Architectural Review Board

August 23, 2022 – 5:30 p.m.

III. Full Review of Items

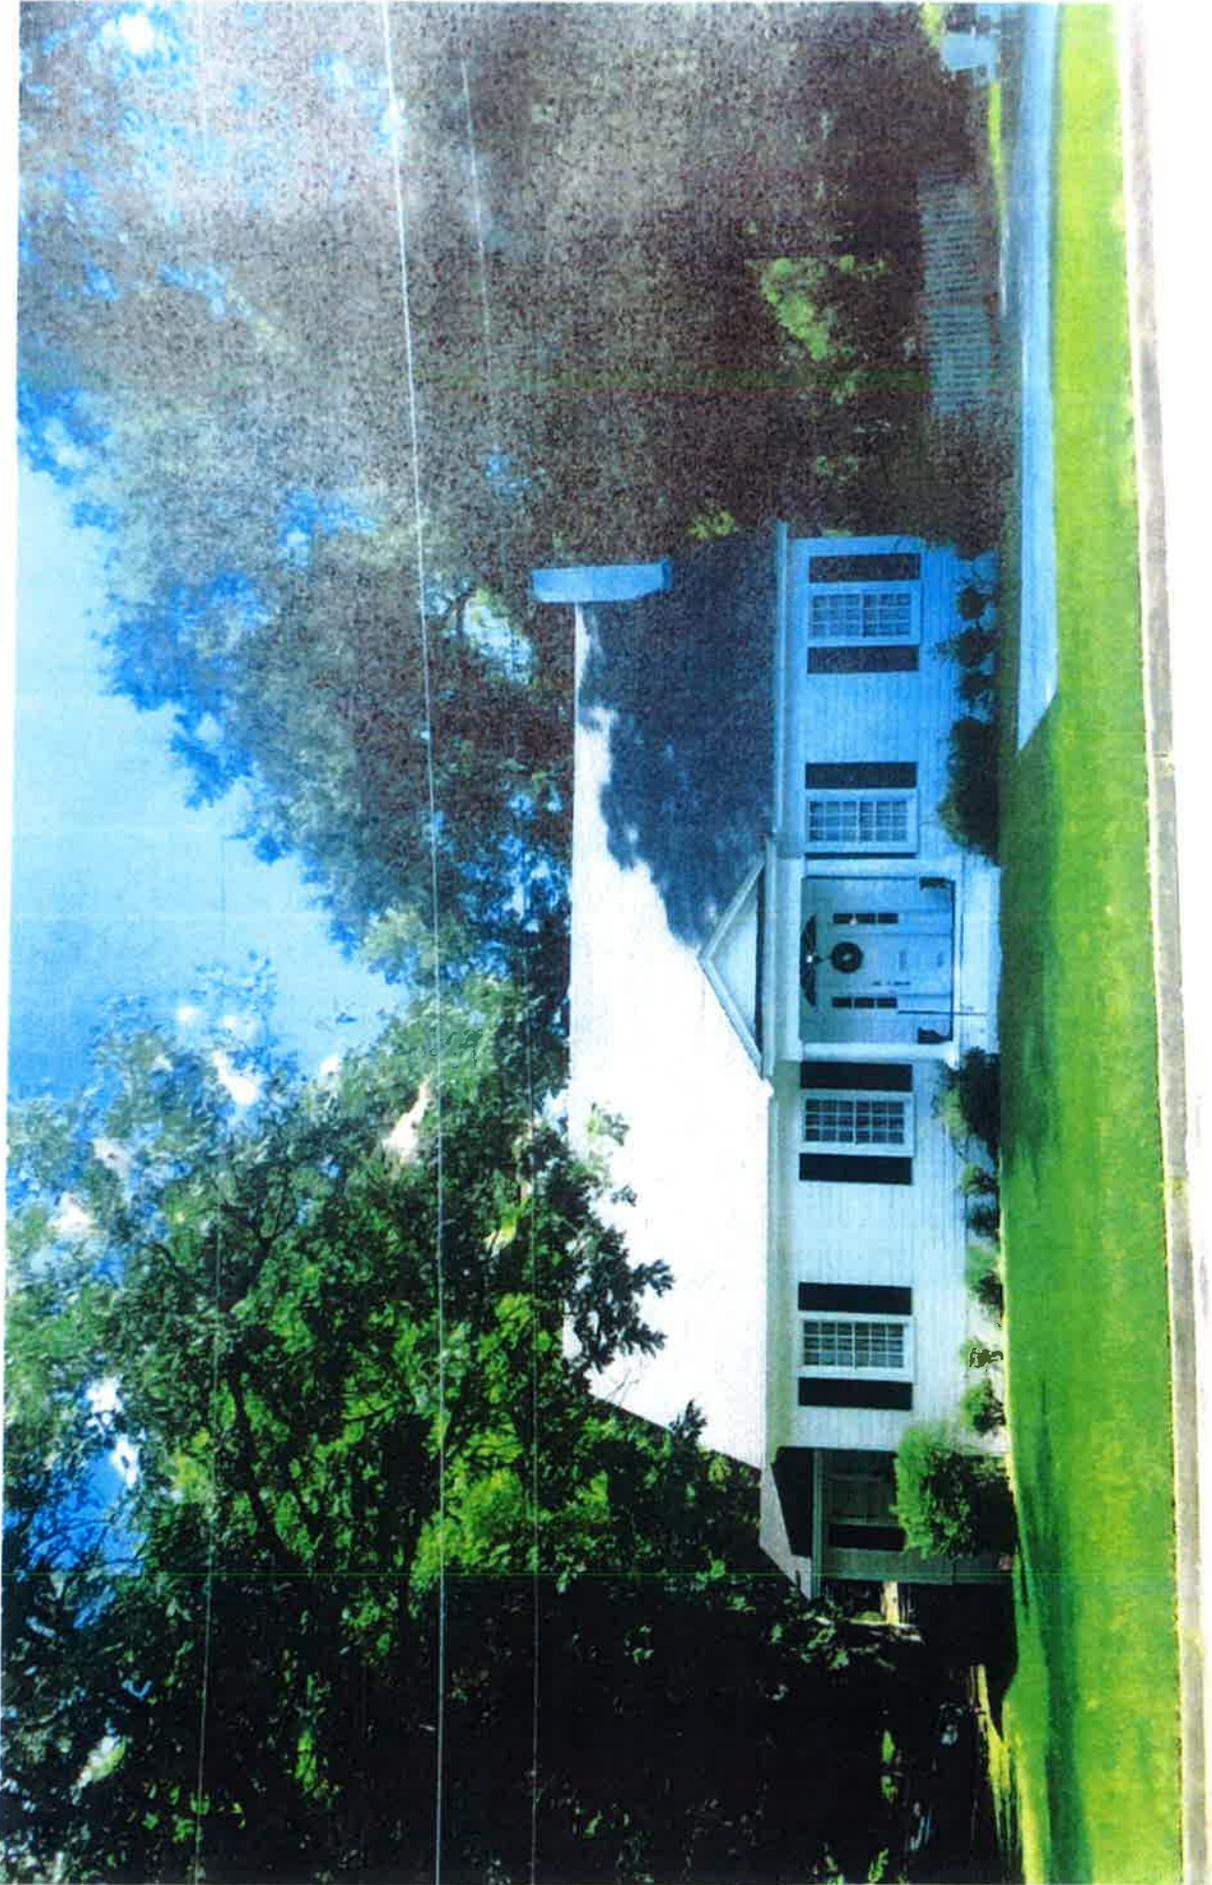
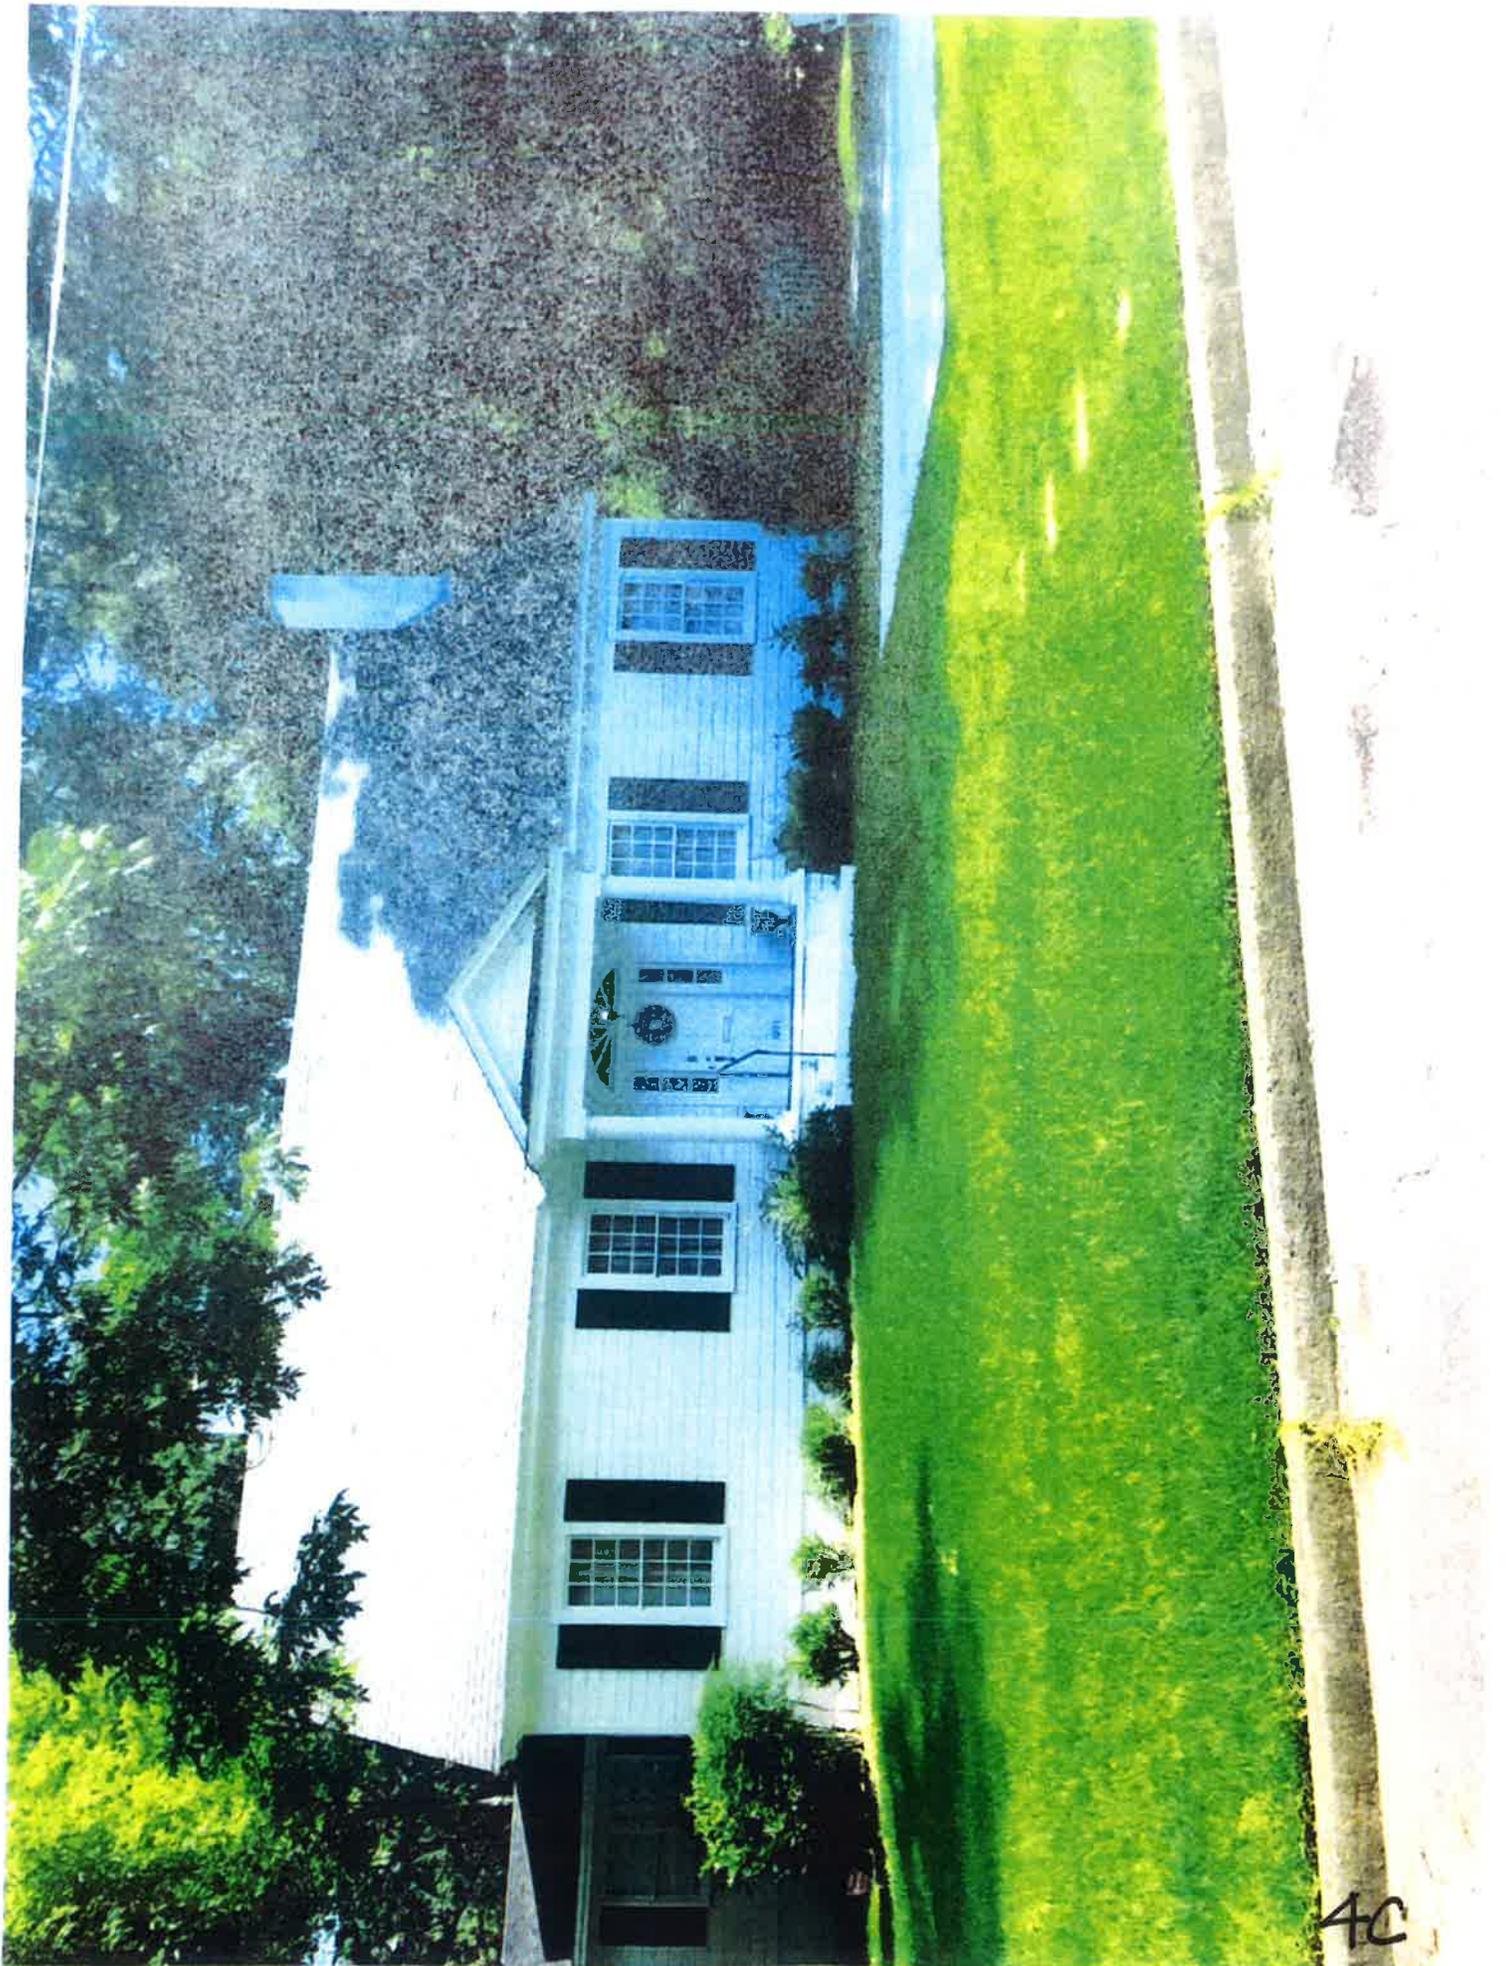
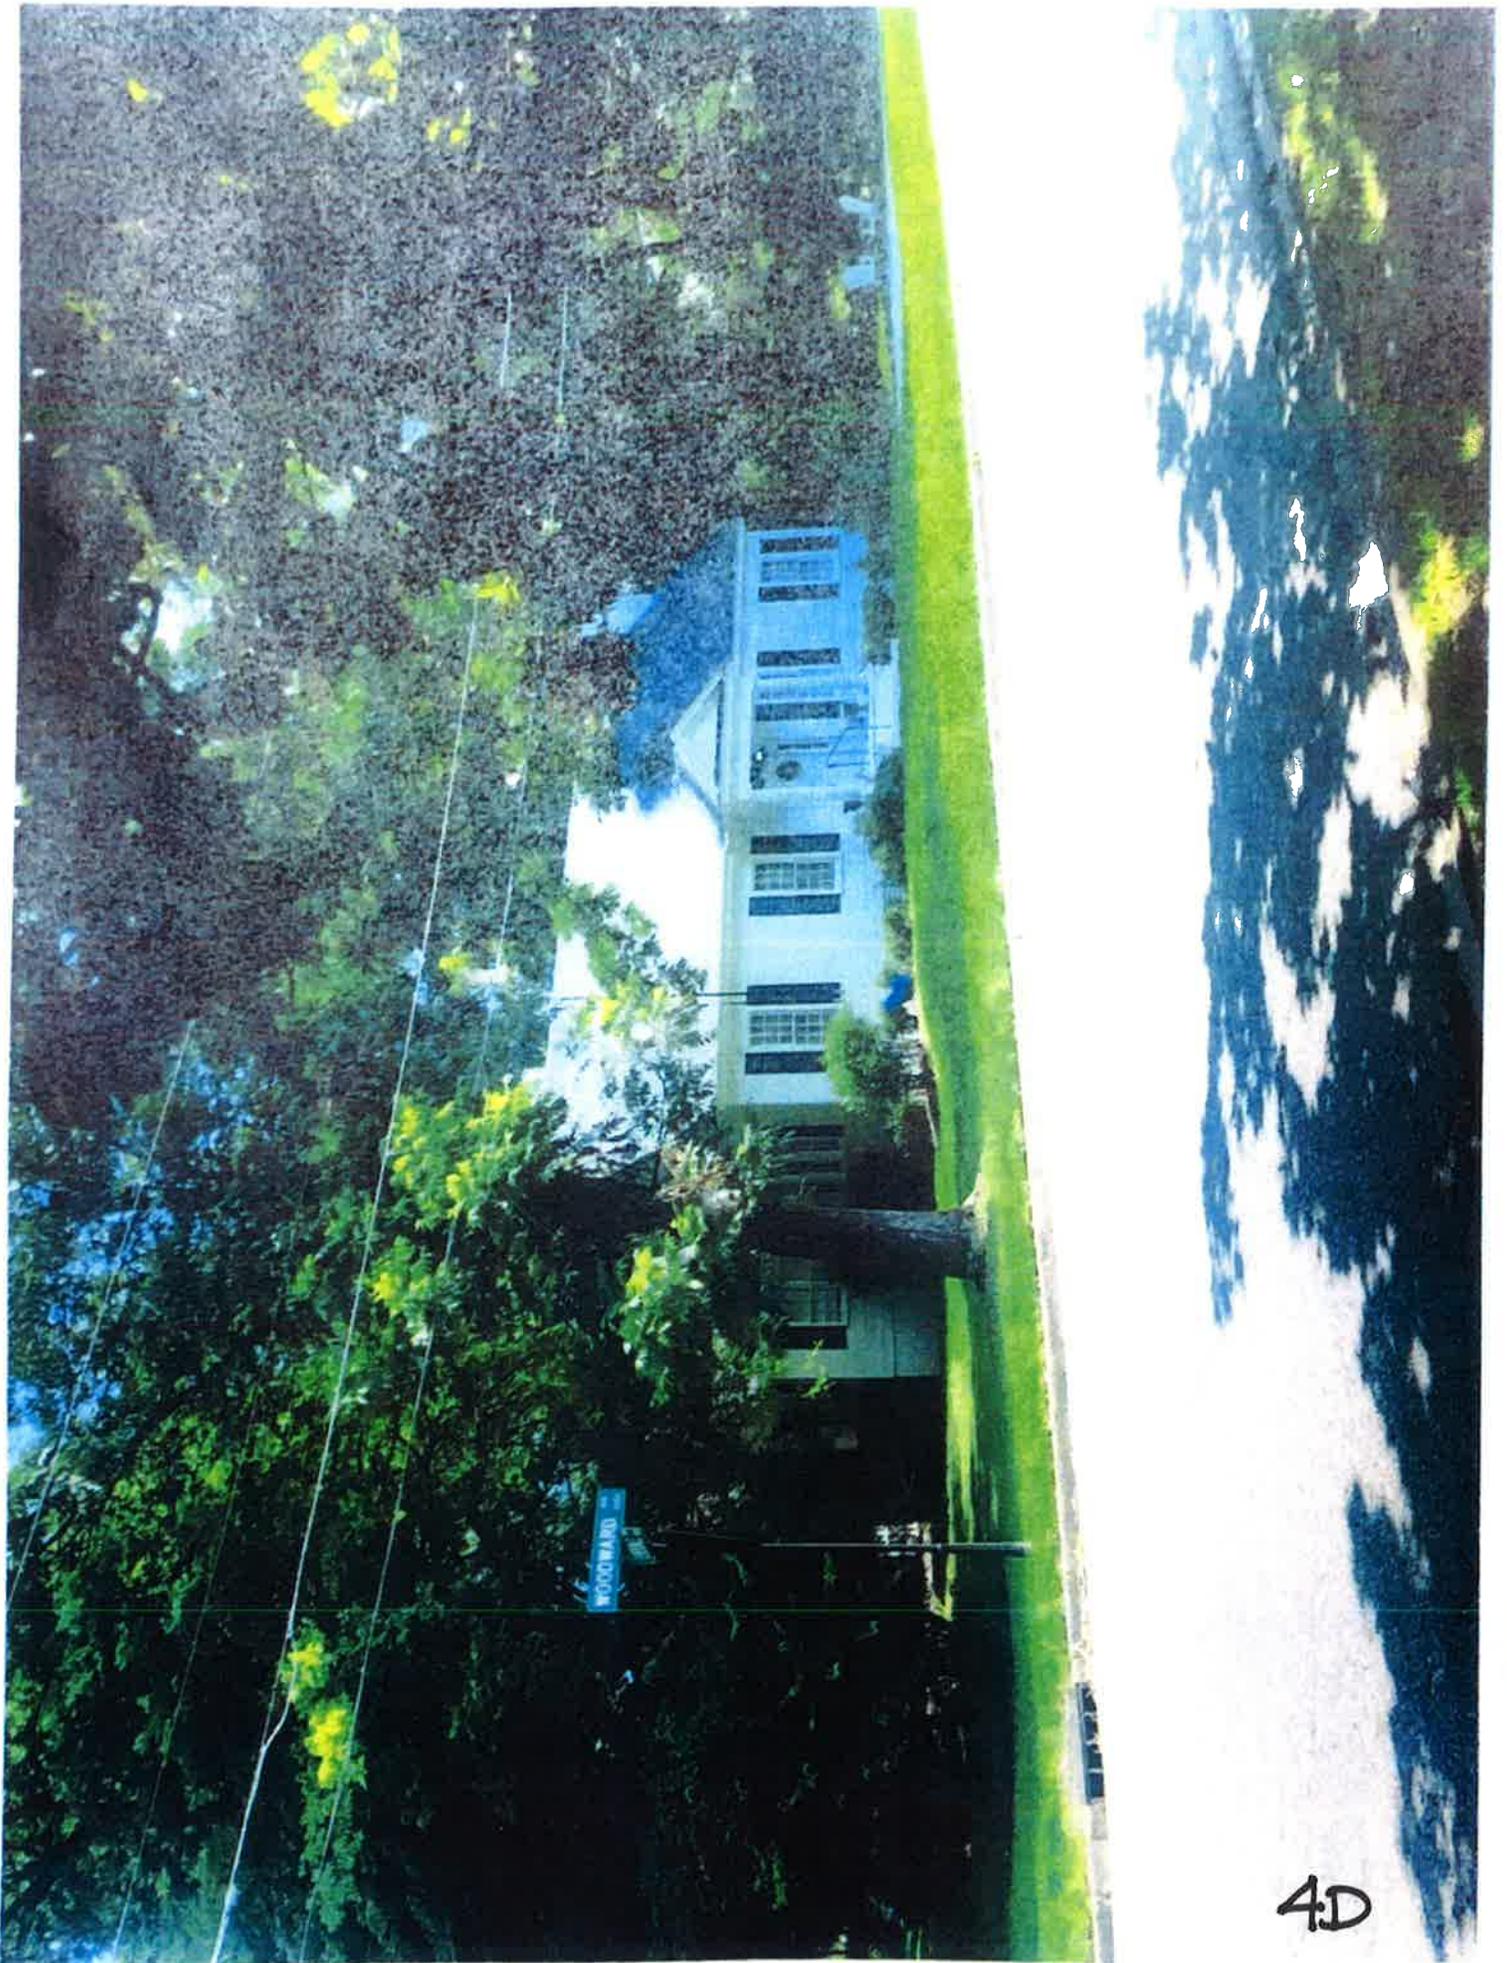
- As with any request for approval after the fact, the question the Board needs to ask itself is would we have approved this request had it been made prior to work being done.
- UF: The size and number of shrubs should screen the parking.
- The ROW in the front yard is approximately 20’, new plant material in the ROW requires approval from the Urban Forester. UF is okay with the plant material if it’s approved by the ARB.
